Bulletin No.: L03-006
Release Date: 7/5/06

SERVICE BULLETIN

Ride Manufacturer: Larson International Inc. Affected Production Dates: All				
Ride Name: Fireball & Ring of Fire with Fireb	all train	Affected	Serial	Nos.:
88PA30043	01PT70088			
89PA50049	01PT70089			
90PA50053	01PT70090			
91PA60056	01PT70091			
92PA60059	02PT70092			
95PA60074	02PT70093			
99PA60081	02PT70094			
99PA70082	03PT70095			
99PT70083	03PT70096			
00PT70084	03PT70097			
00PT70085	04PT70098			
00PT70086	04PT70099			
00PT70087	05PT700100

Restraint Bumper Installation

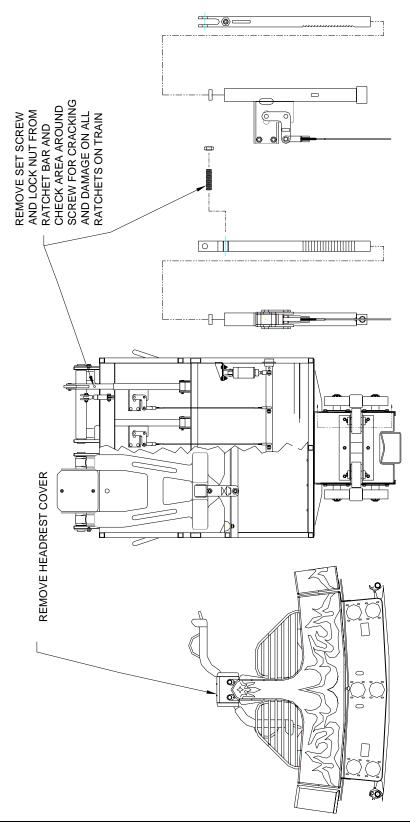
Larson International Inc. has learned that some parts of the Fireball over the shoulder ratchet assemblies on the passenger vehicles are being bent and or damaged causing safety concerns for the ride. The damage occurs when the restraint is "slammed" shut on an unoccupied seat. There is reasonable concern that this damage could result in a restraint failure.

- 2. Remove stop set screw and locknut from upper portion of ratchet assembly.
- 3. Add bumper assembly under over the shoulder restraint and weld in place. (see instructions)
- 4. Welding must be completed by AWSD1.1 certified welder.
- 5. N.D.T inspection of bar at the point where the stop set screw was located is required.
- 6. If upon inspection there are signs of bending and or cracking replacing the ratchet bar is necessary.
- 7. A copy of the inspection report must be sent to Larson Intl, Inc.
- 8. This modification must be completed no later than July 21, 2006. If modifications & N.D.T. are not complete by this date the ride must be taken out of service until testing & modifications are complete

Mount brackets flush with channel.
